April 19, 2022

Re: On-Going Services
Public Improvements Acceptance of Riverwood Ranch Section 2 Subdivision
Angleton, Texas
HDR Job No. 10283980

ENGINEER'S CERTIFICATE OF COMPLETION

RIVERWOOD RANCH SUBDIVISION
SECTION 2
A 78 AC, 109-LOT SUBDIVISION
ANGLETON, TEXAS 77515

**RIVERWAY PROPERTIES
6115 SKYLINE DR. STE A.
HOUSTON, TEXAS 77057**

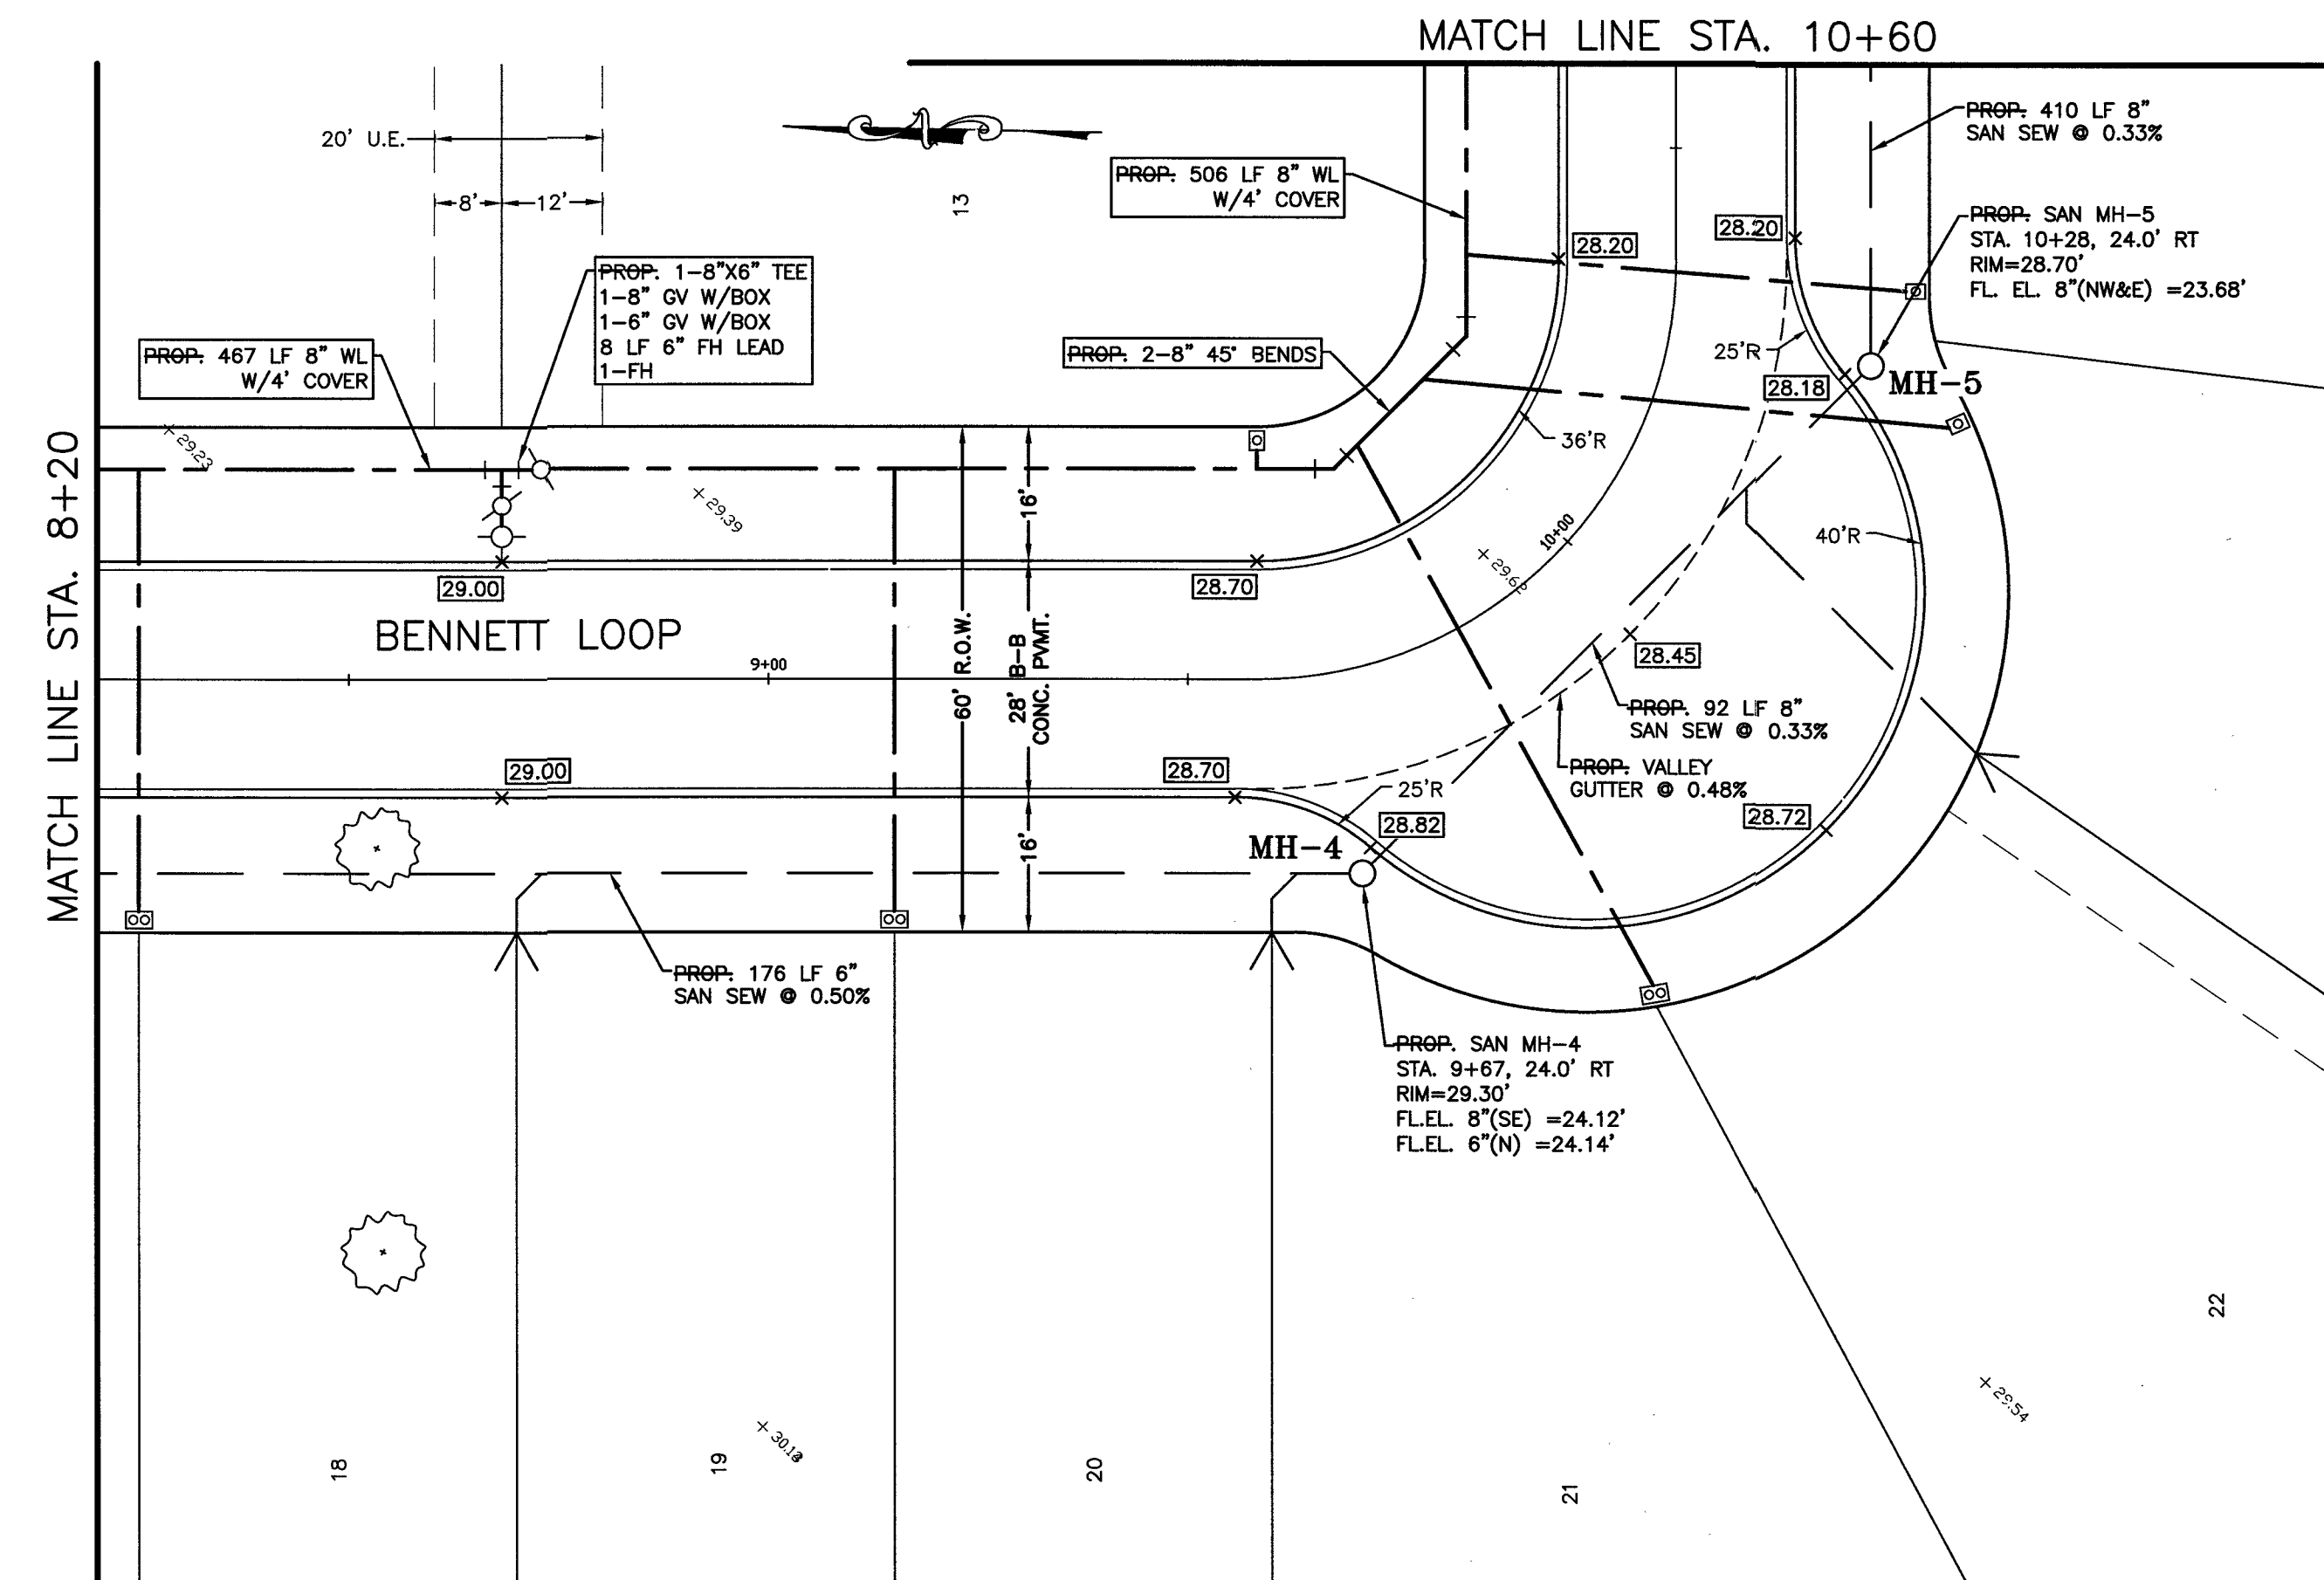
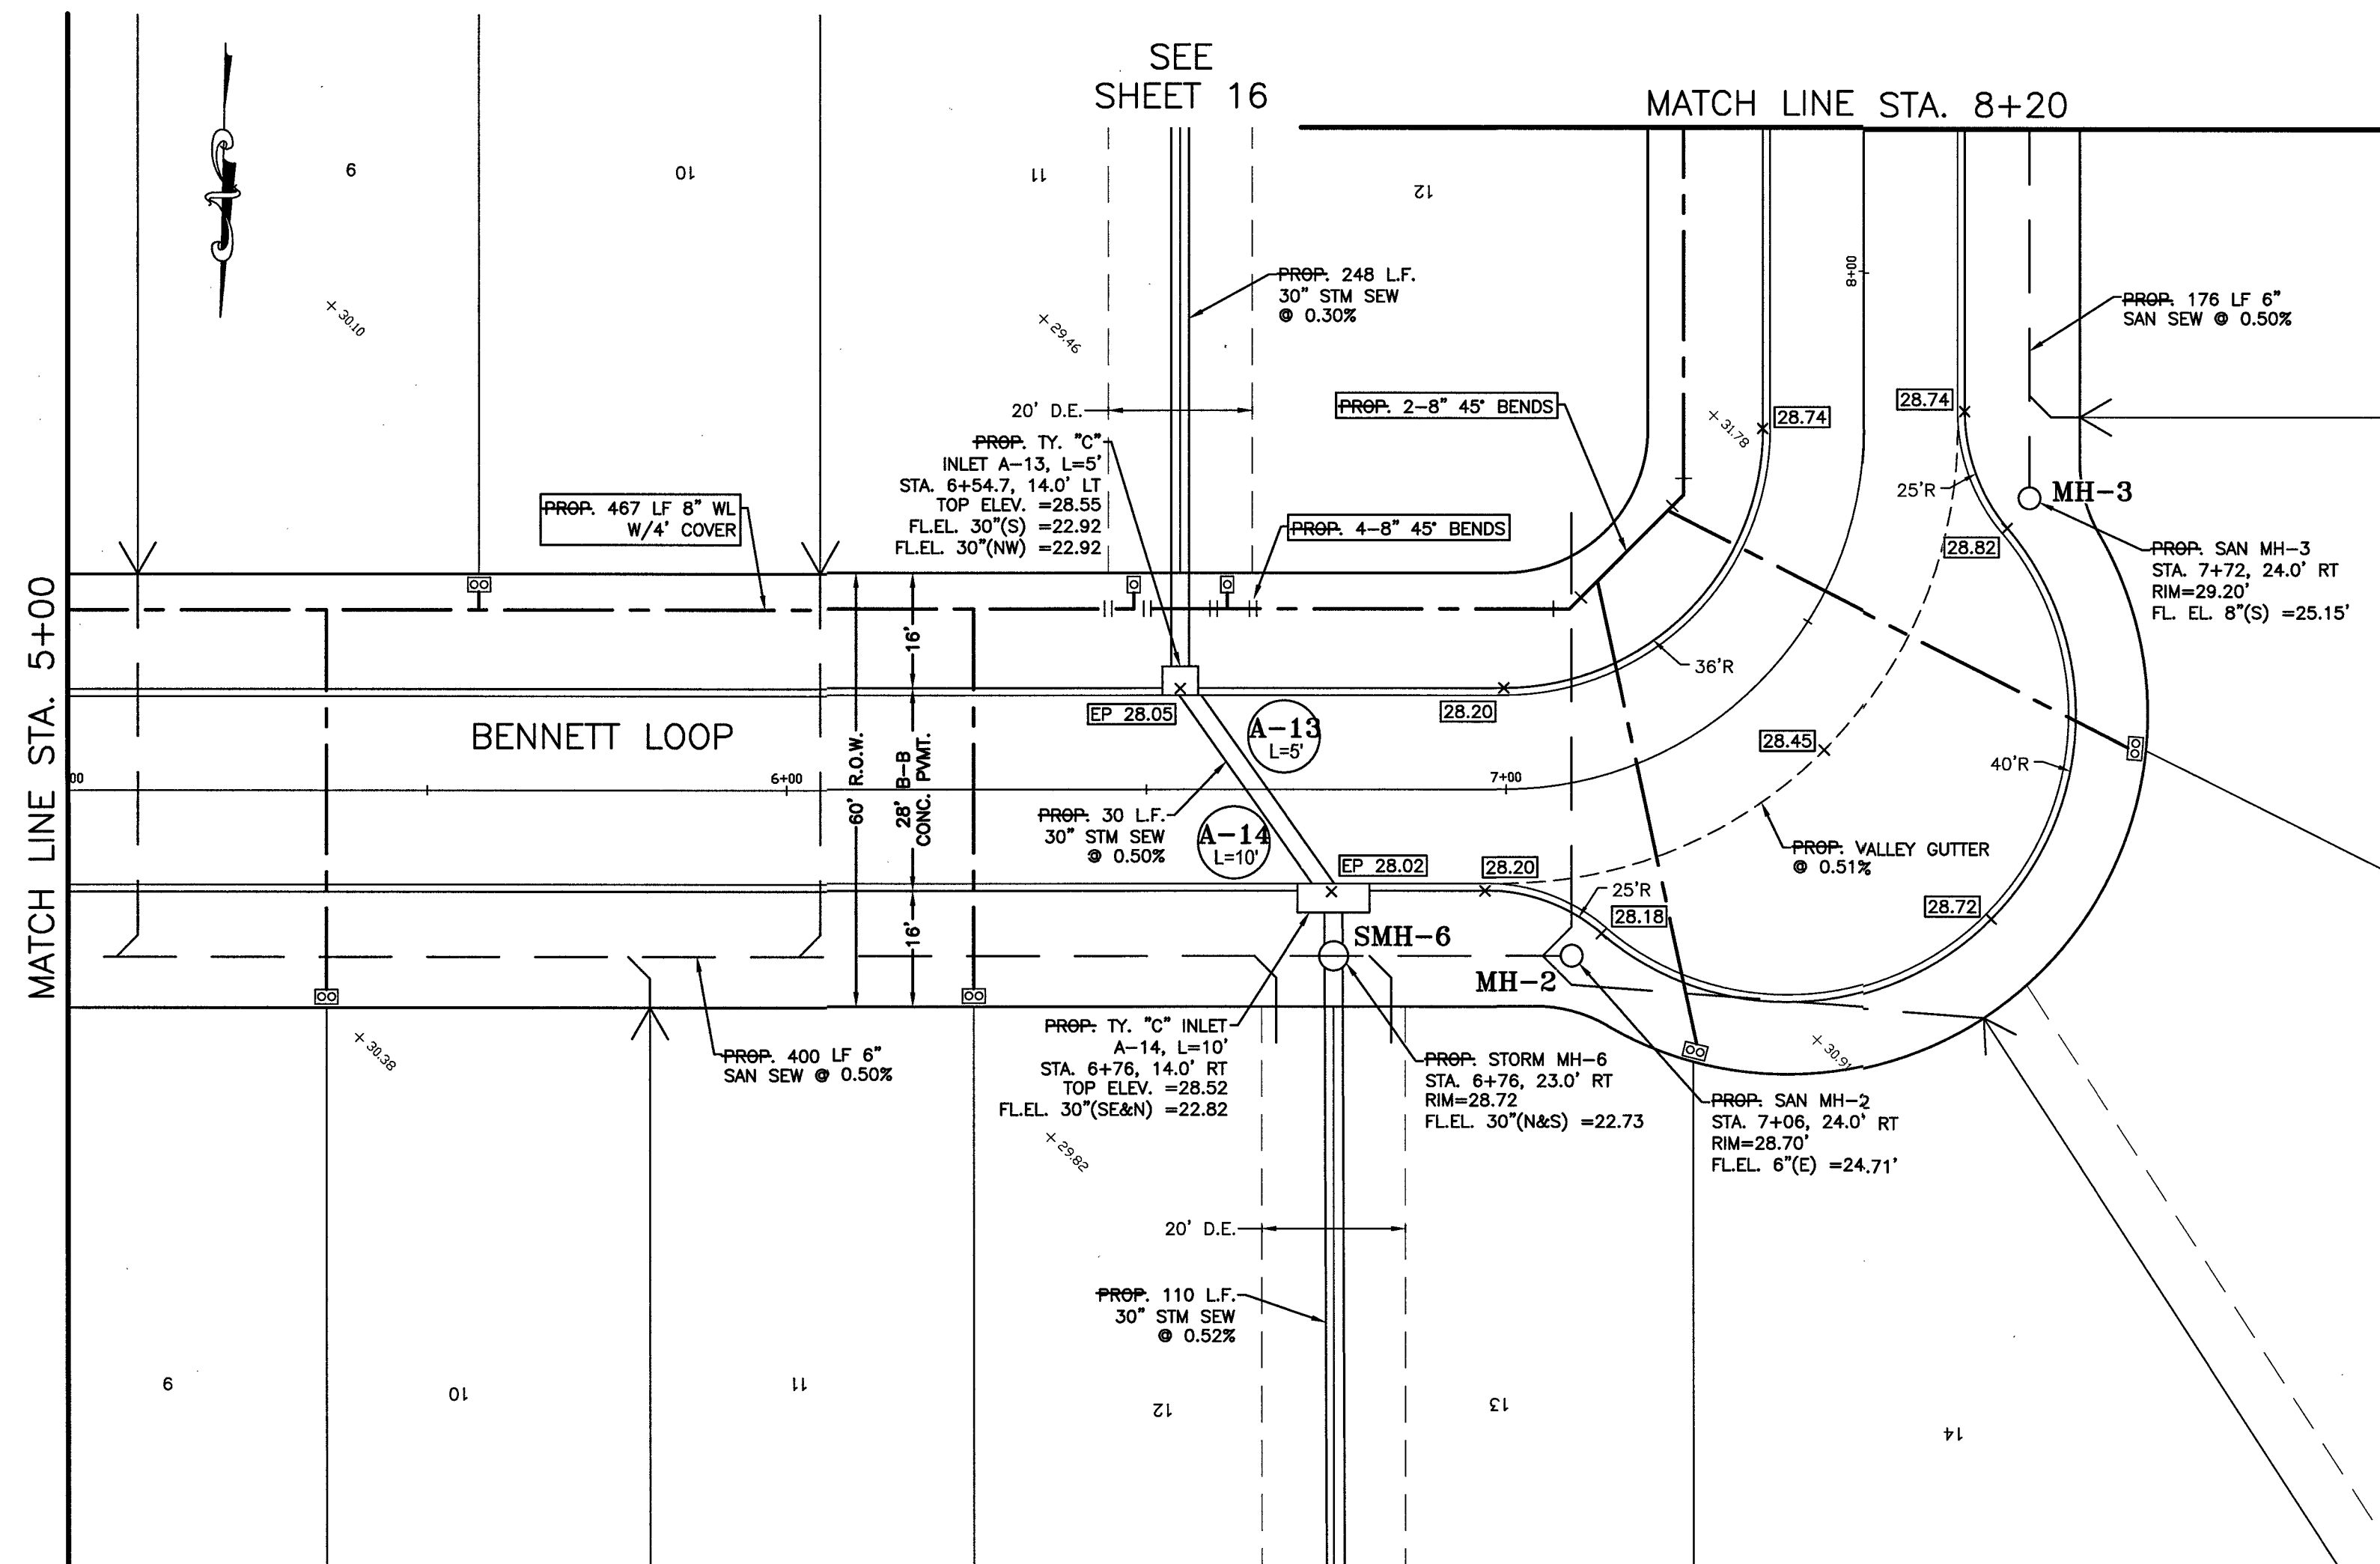
2. During the Final Inspection Walkthrough, a portion of concrete street paving near STA. 4+35 of the left lane on Bennet Loop was noted to have cracking. Public Works has directed the Contractor (Matula & Matula Construction, Inc.) to crack seal this area at this time and that a review of this panel and other street portions shall be provided 1-month prior to the end of maintenance period covered by bonding. Replacement of this concrete panel will be dependent on review of the cracking and if this deficiency has increased over the 1-year period.
